BRKDD50M Datasheet
Product Revision: Rev B

Changes

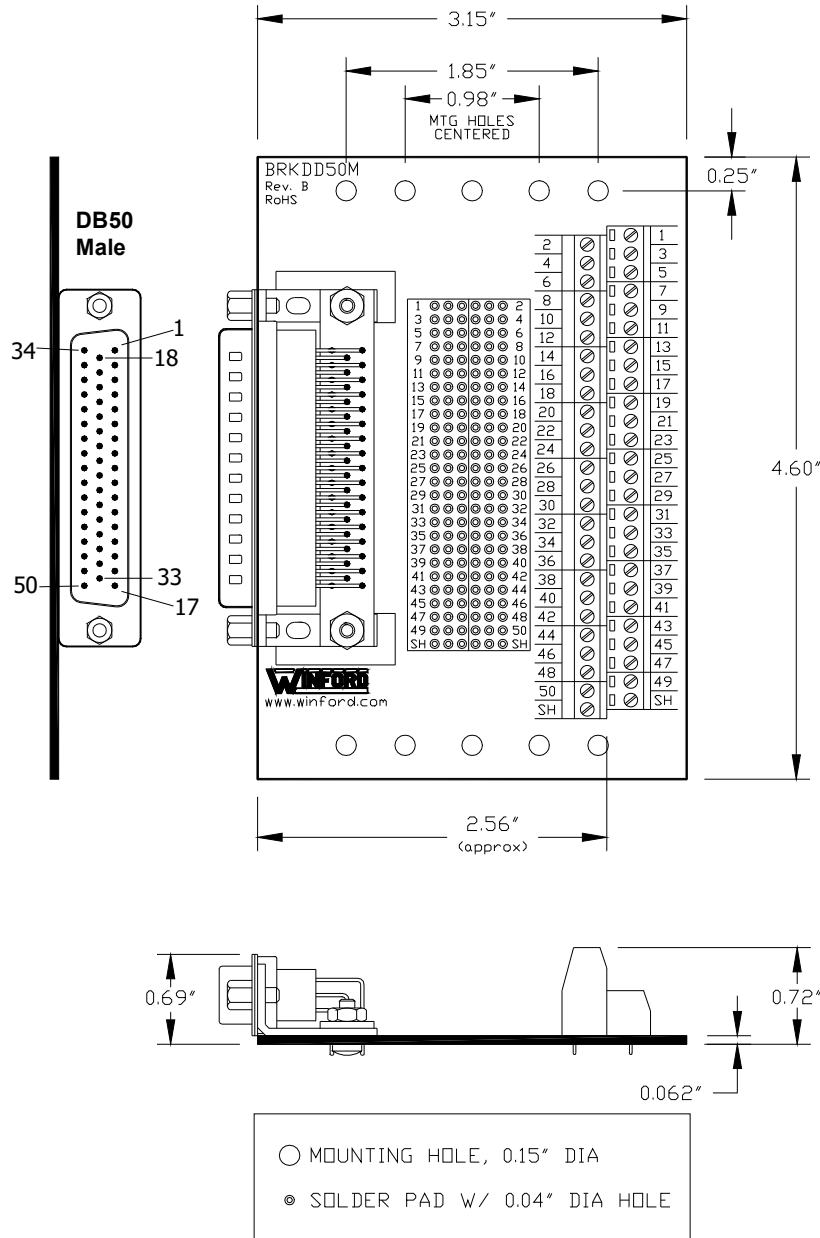
| Date | Description |
|------------|--|
| 07/28/2010 | Rev B Changes: <ul style="list-style-type: none"><li data-bbox="337 275 1144 302">• Brought DB50 Shield/Shell connection out to new solder pads and screw terminals<li data-bbox="337 306 927 333">• Larger print on silkscreen number labels by screw terminals<li data-bbox="337 338 914 365">• NOTE: Board size and mounting holes remain unchanged |
